**NM1 -     5**

**MAJOR  
MODIFICATION**

**Application  
Replacement Pages  
and Replaced Pages**

**From:** Hansen, Edward J., EMNRD  
**Sent:** Wednesday, August 05, 2009 3:28 PM  
**To:** 'bdinc@digii.net'  
**Cc:** 'Pamela Gonzales'; 'Keith Gordon'; Jordon Eng; Jim Jordon  
**Subject:** NM1-5 Additional Information Required for the revised Application for Basin (Ponds #2 & #3)

PROJECT #: 520.01.01  
ATTACHMENT III.I.C

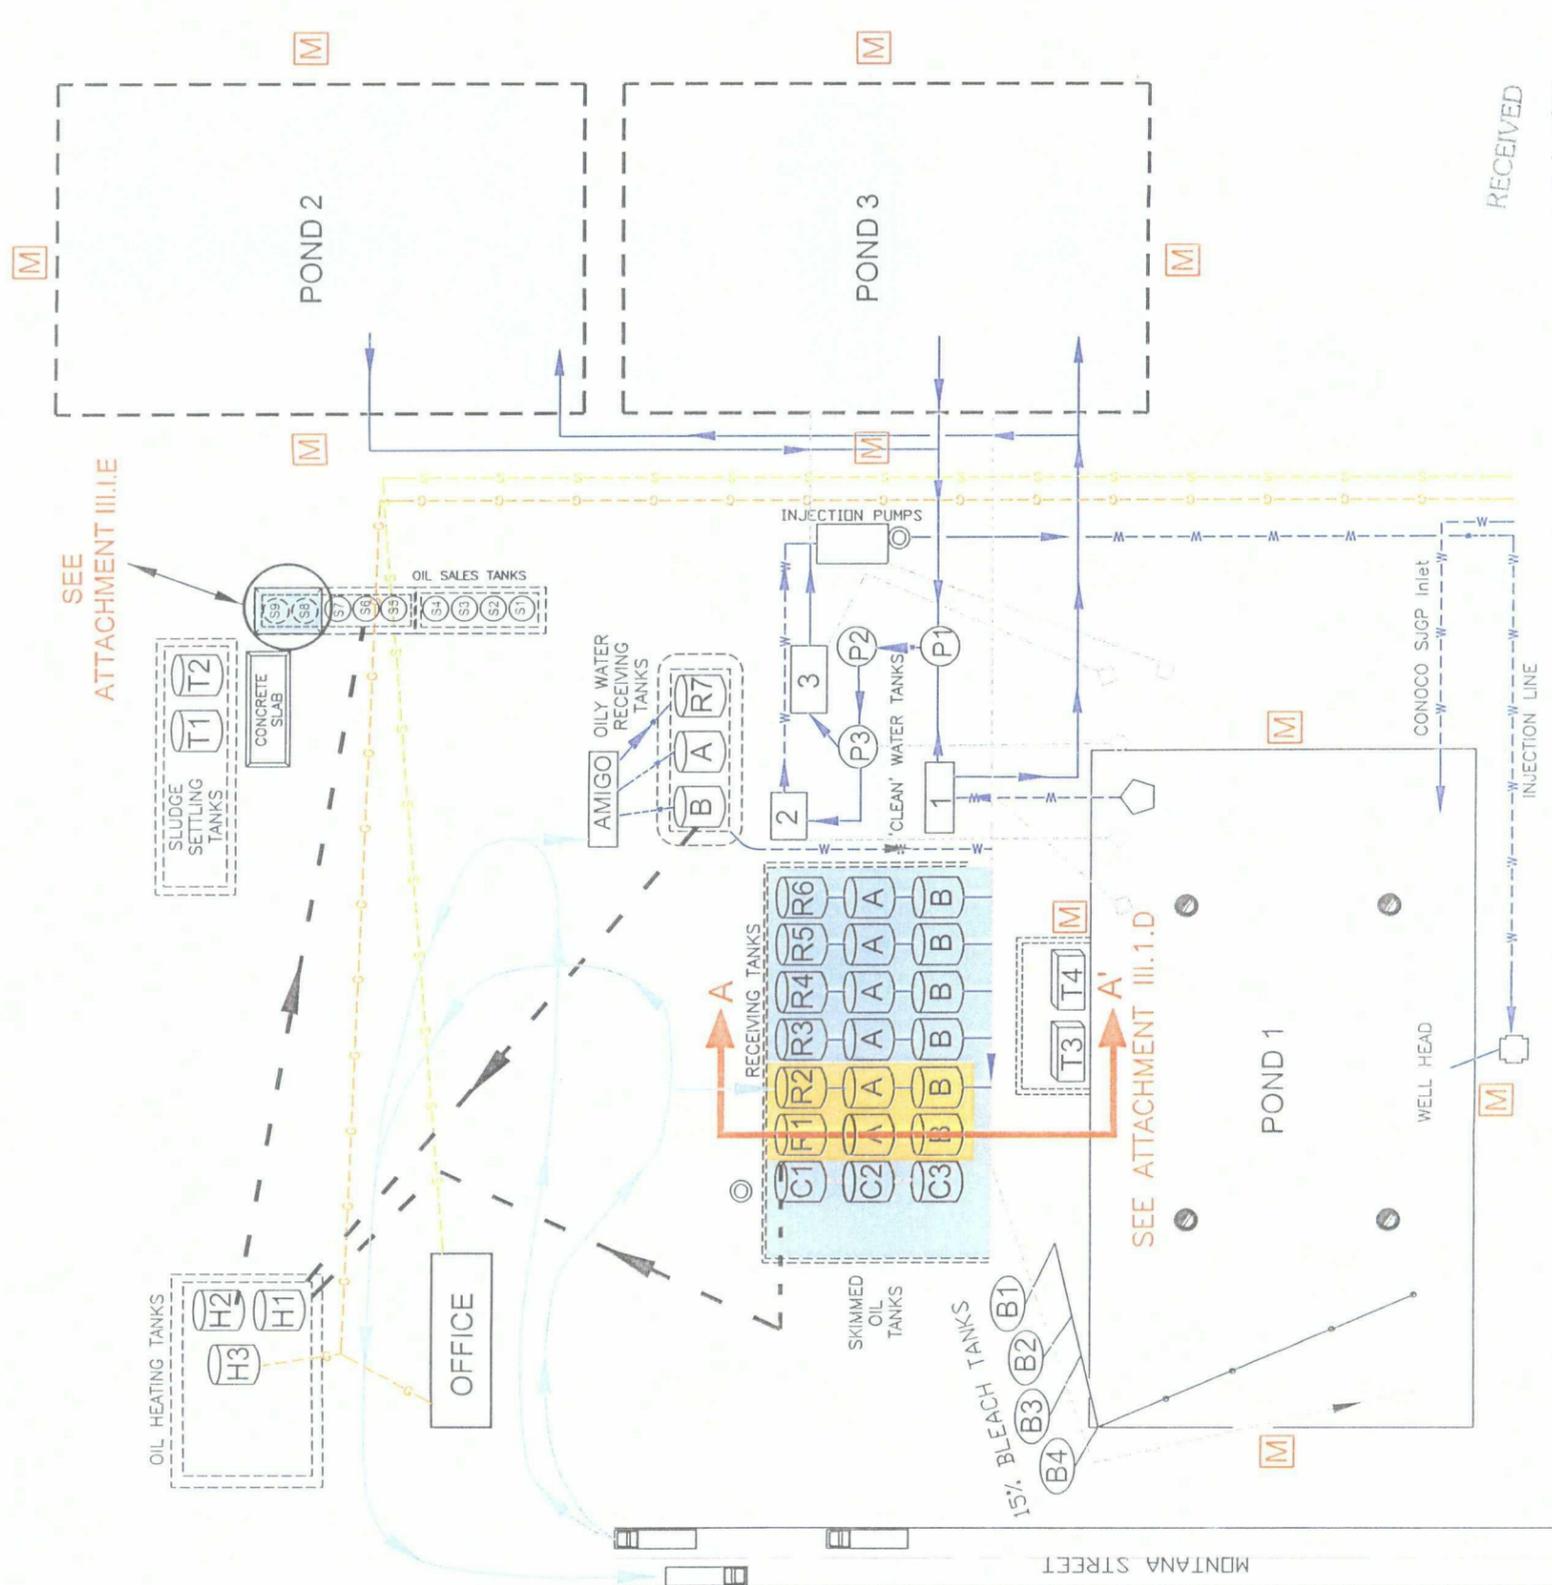
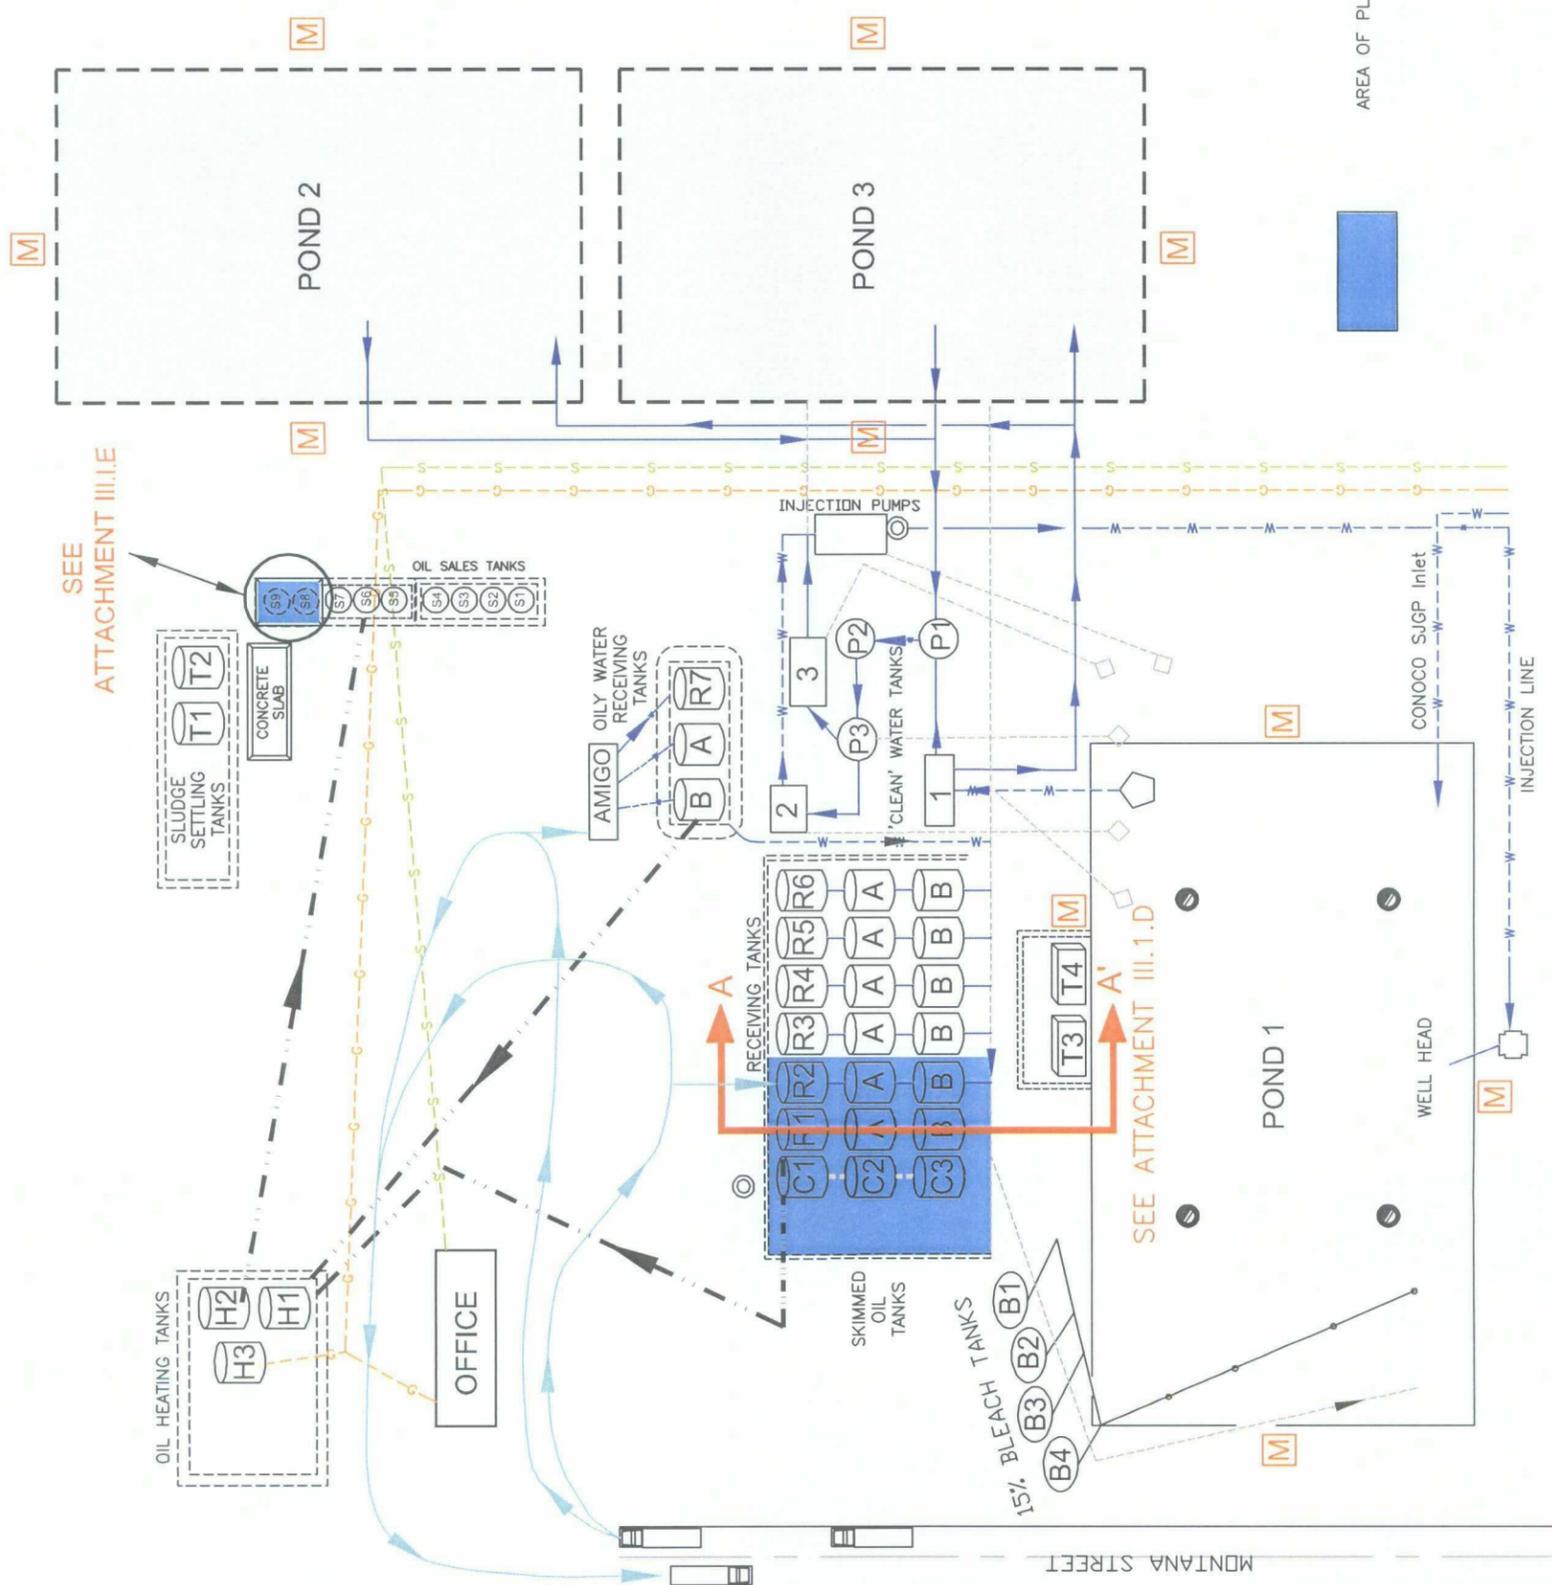
8. On page 7 of Section 1 (7.0), Vol. III, please describe the exact placement for the 6 "new" proposed receiving tanks (e.g., three of the six new tanks will be placed on the east side of the three existing oil skimmer tanks and the other three new tanks will be placed on the west side of the existing oil skimmer tanks)

As proposed in this Application, two (2) additional oil sales tanks and six (6) receiving tanks will be installed. Currently, Tanks 9, 10, 11 will be moved over two tank lengths and rotated so as to be oriented east to west instead of the current north to south. The six new tanks will be repositioned in between the new skimmer tanks and the existing water receiving tanks. Detailed operations of the tanks are prescribed in **Volume II, Section 1**, "Operations, Maintenance, and Inspection Plan". The new tanks will be constructed with underlying continuous 30-mil polyester bermed liner systems, extended from the existing system and designed to capture any fluids within the watershed of Pond 1 (**Attachment III.1.C**).
